## CITY OF WICHITA PRIVATE PROJECT NO. 0074 PPD (607861)

## AS BUILT PLANS

Note: Partial As-Built. McCullough Excavation is providing As-Built Information on storm sewer Pipe and Structures and Bio-Swale only. As-Built Information on Grading and other Drainage Improvements to be provided by others.

PRIMROSE SCHOOL  
2072 N. 127TH. STREET EAST  
**AT REED'S COVE**  
WICHITA, KANSAS

## PLAN LINE 1

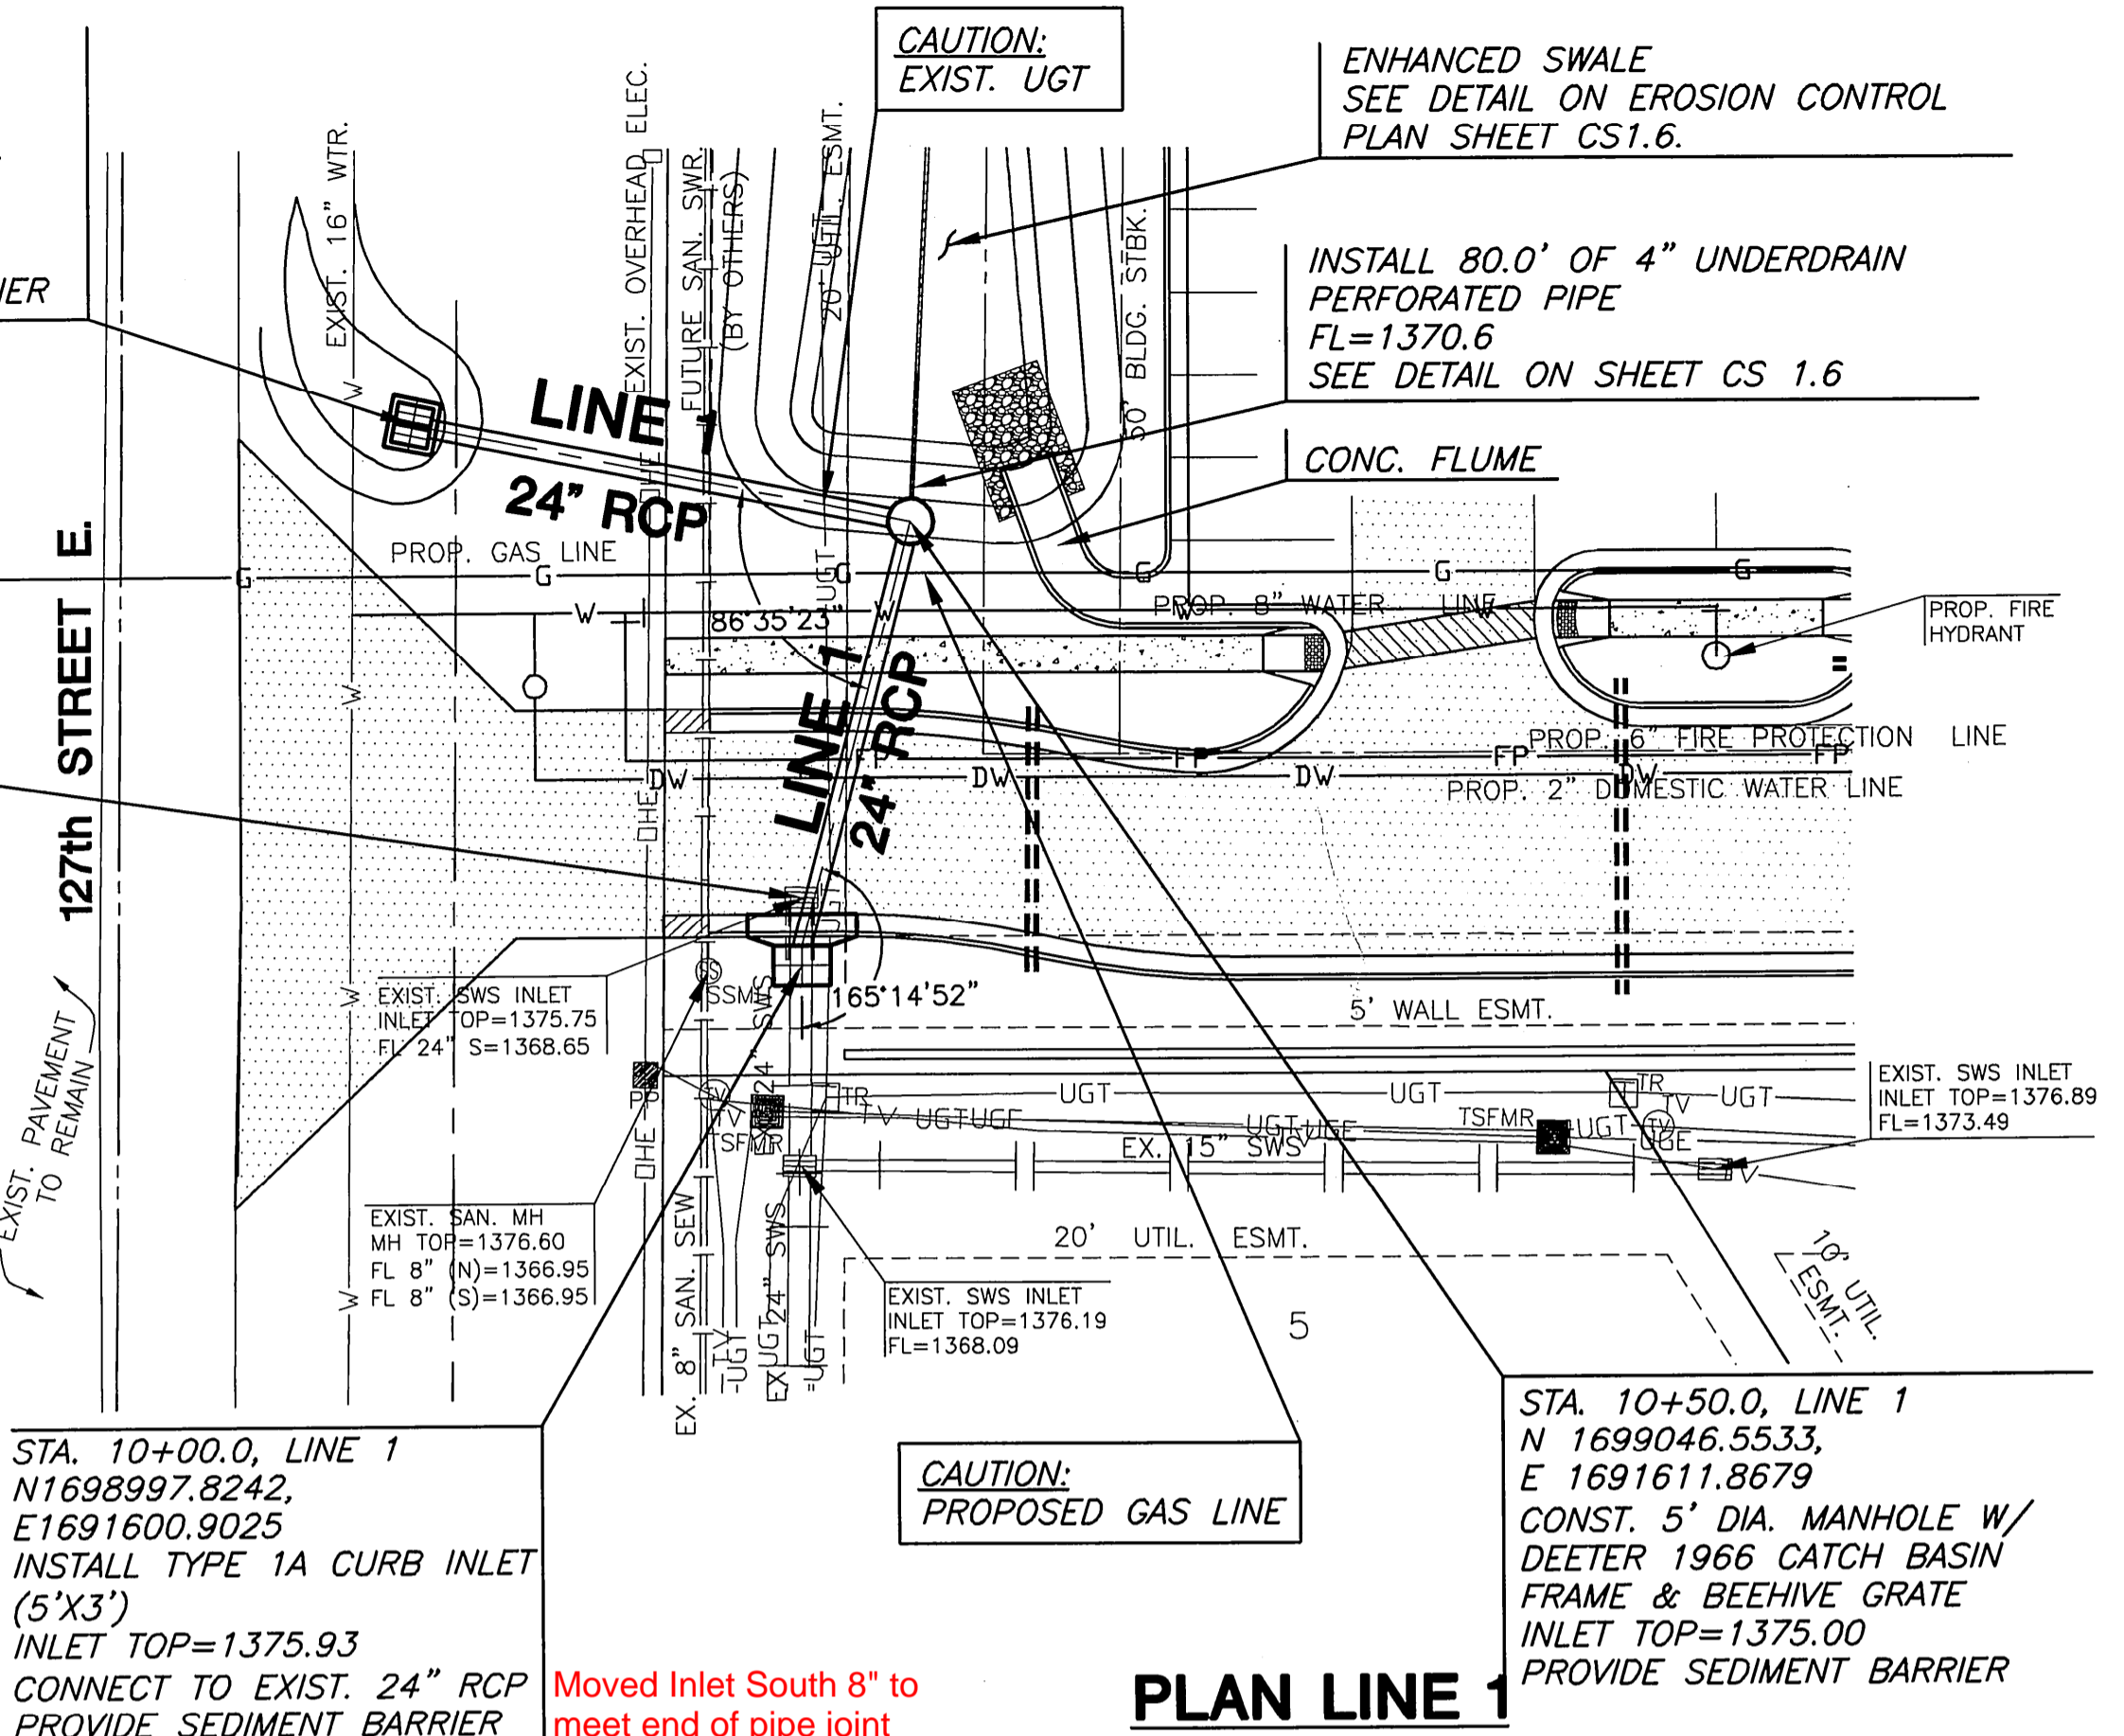
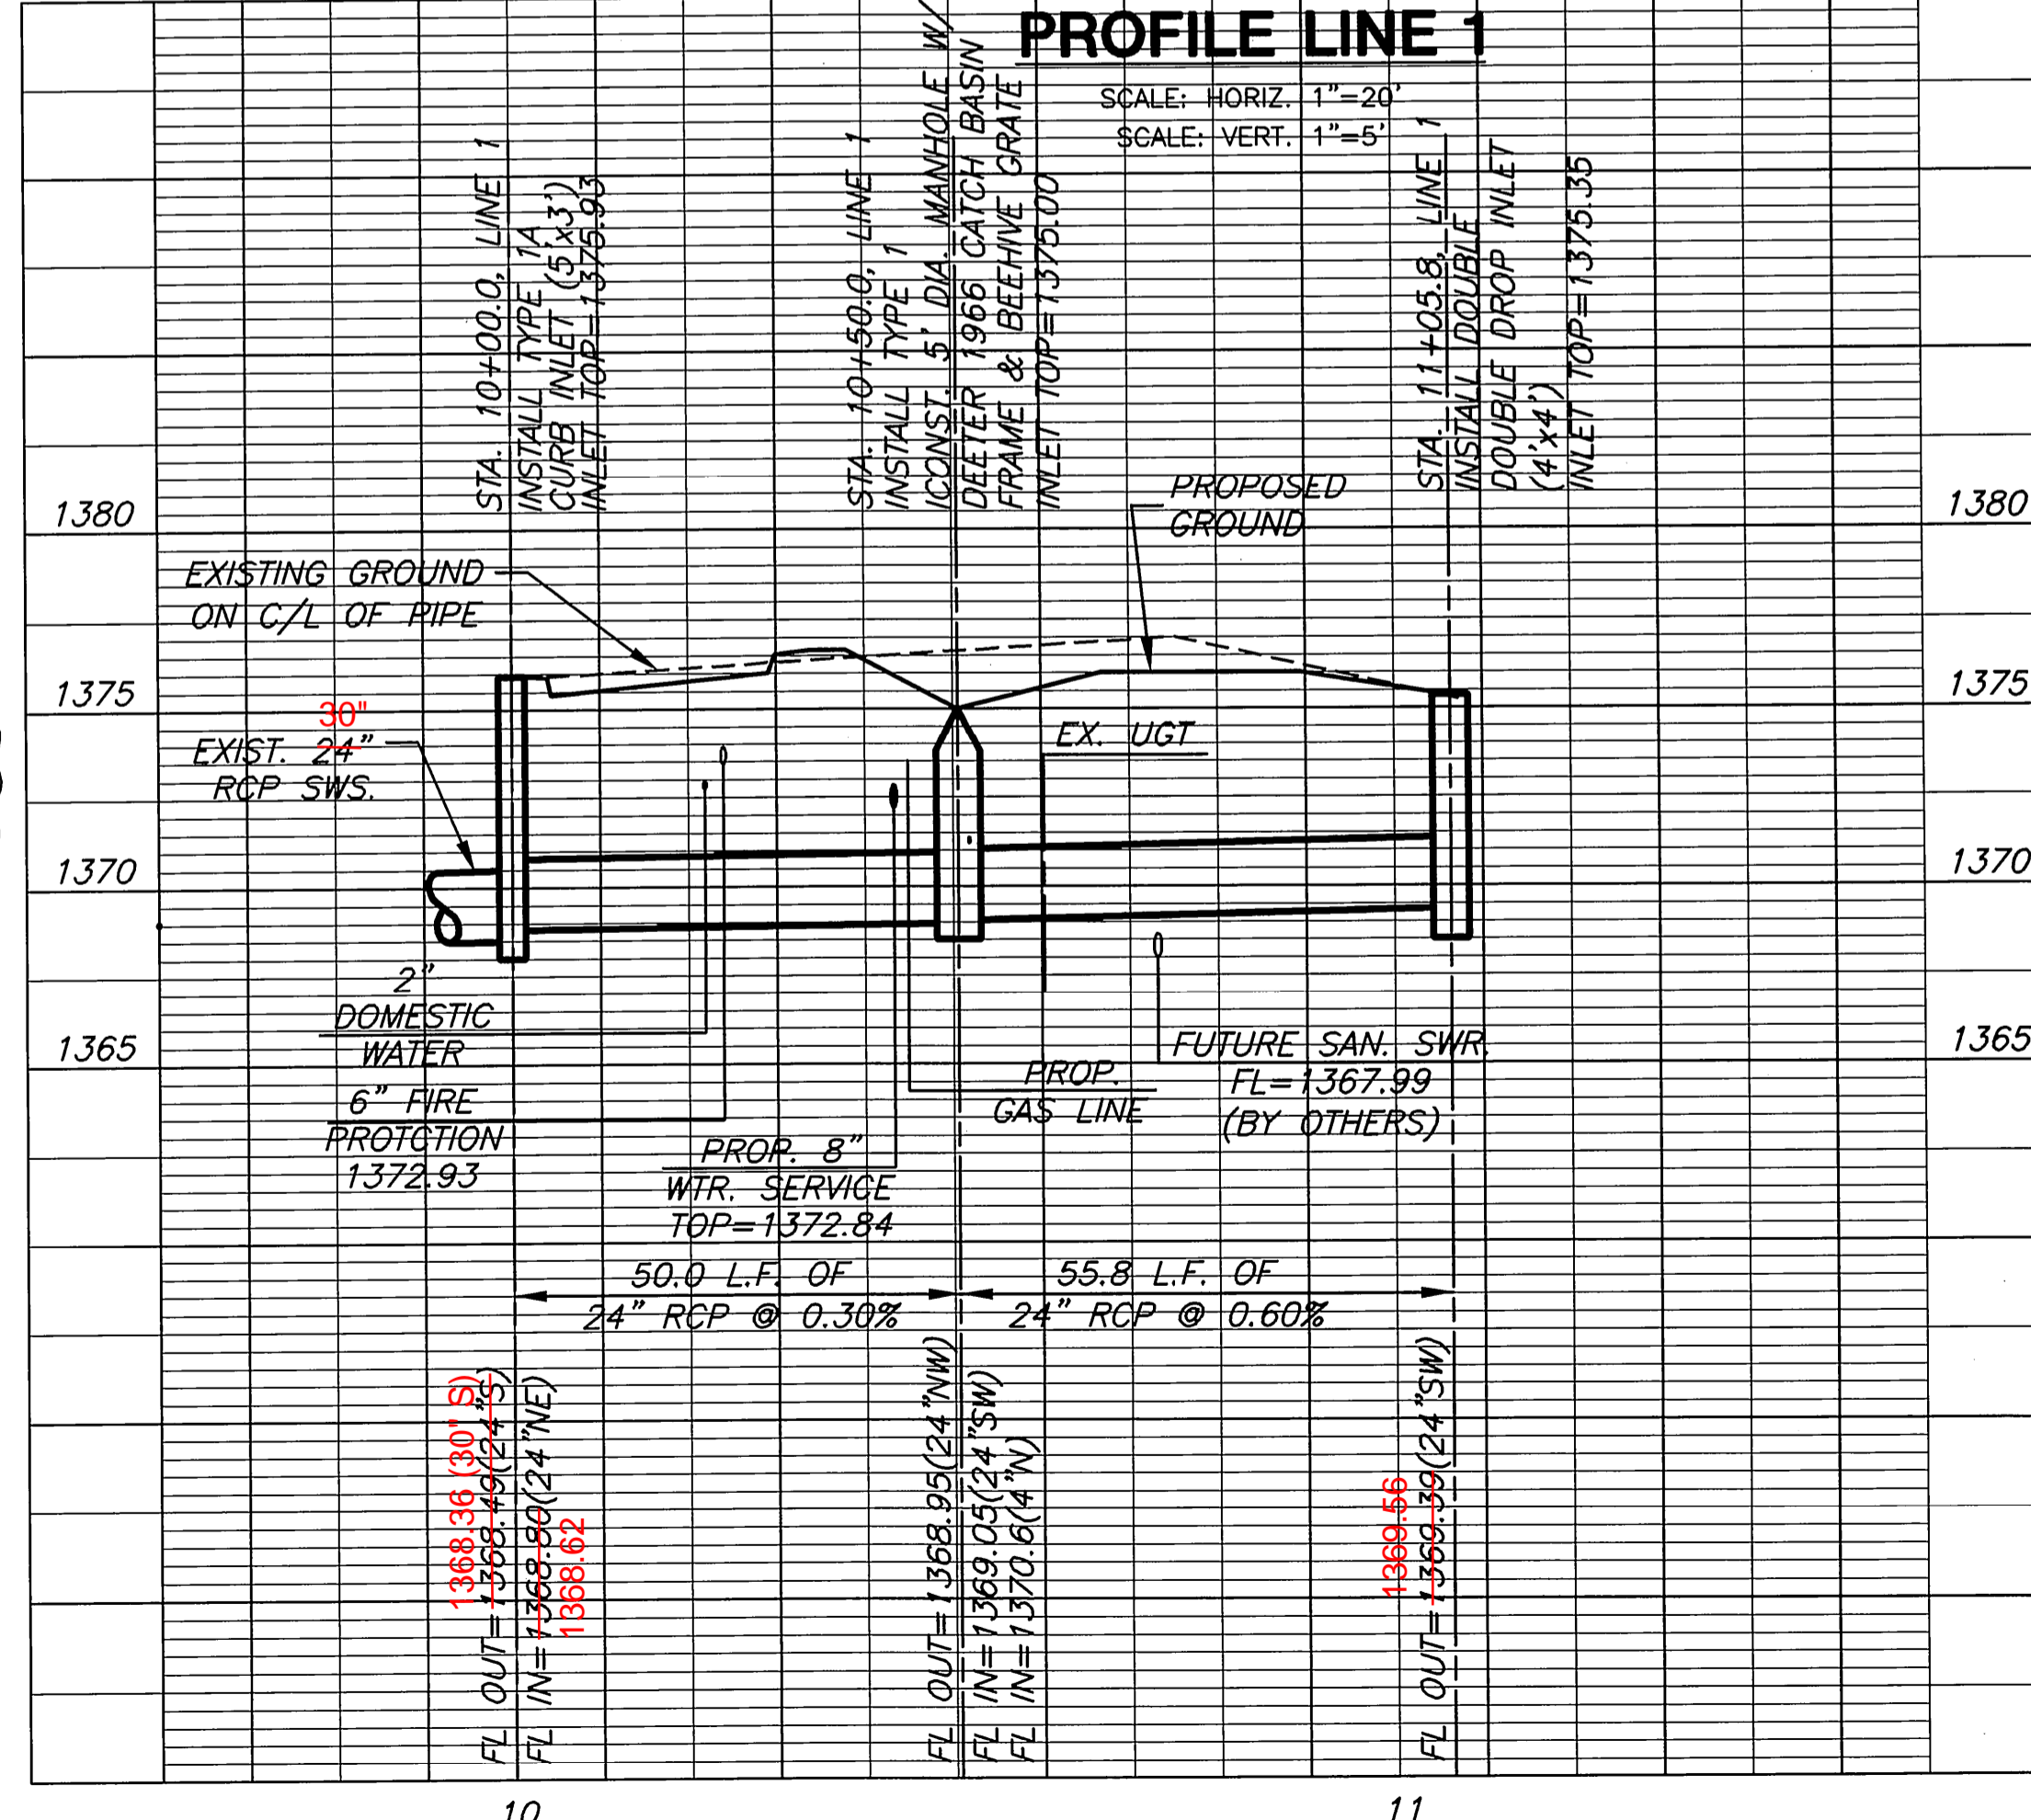
Moved Inlet South 8" to meet end of pipe joint
